# mk1 C920 PCBA wiring

## New C920 wiring

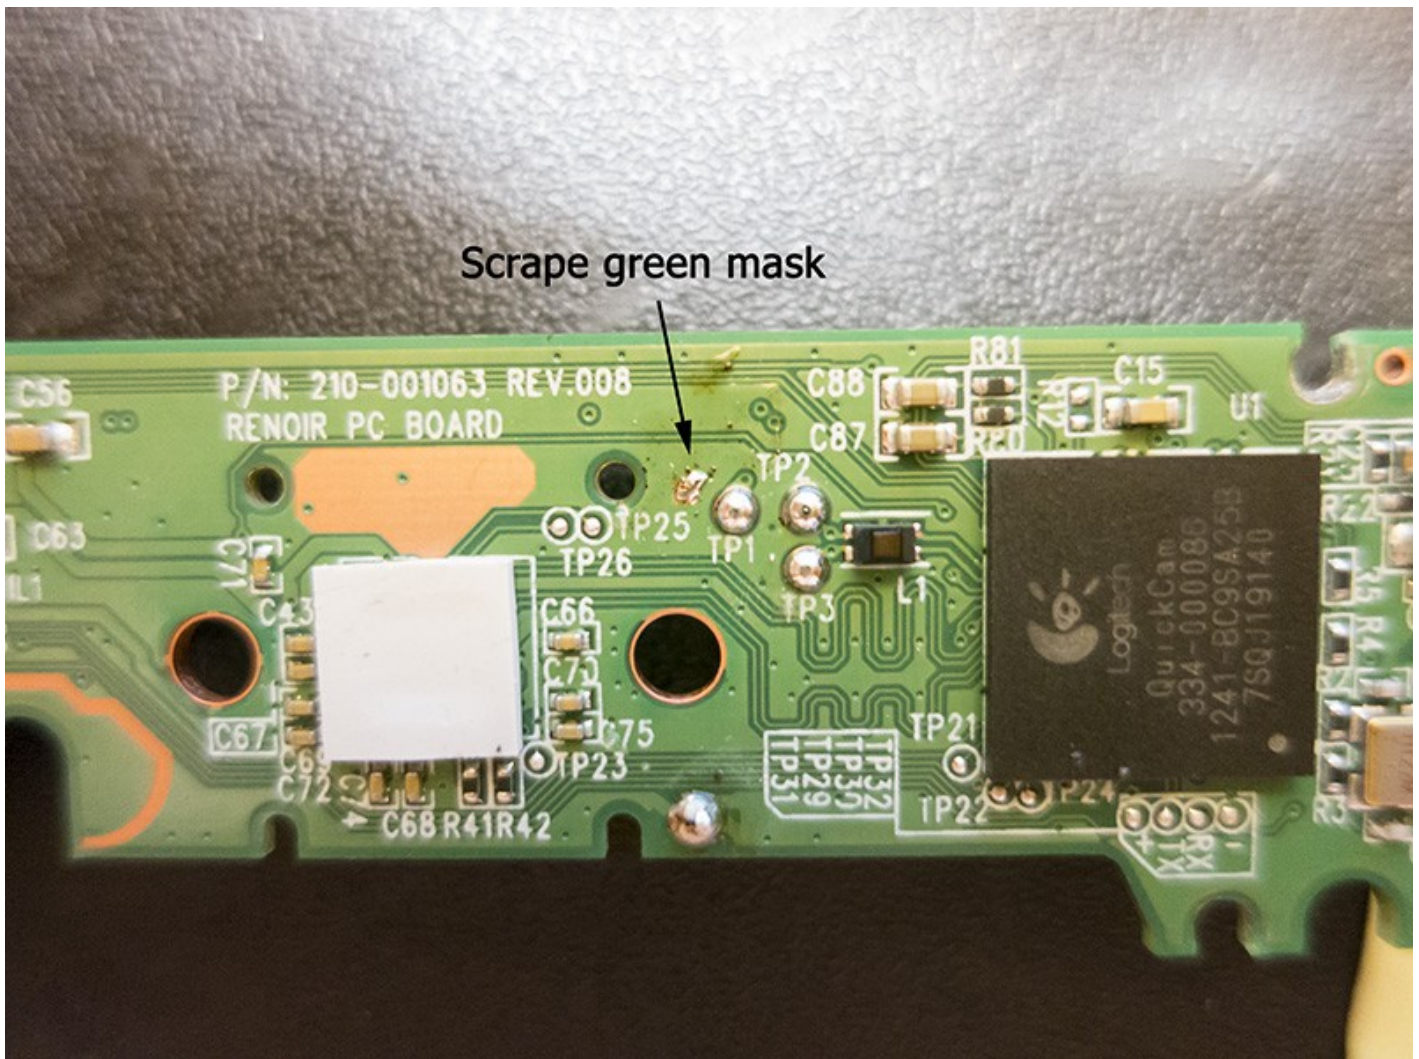
Recently updated C920 webcam version was released featuring new PCB. These changes introduced two unexpected issues: wiring is different and new PCB has mechanical interference with aluminium rework kit back plate.

If you rework webcam by yourself, please use pin-out diagram as pictured below to solder wires.

Test point	Signal
TP24	VCC
TP26	USB D+
TP25	USB D-

green soldering mask with scalpel to access GND.
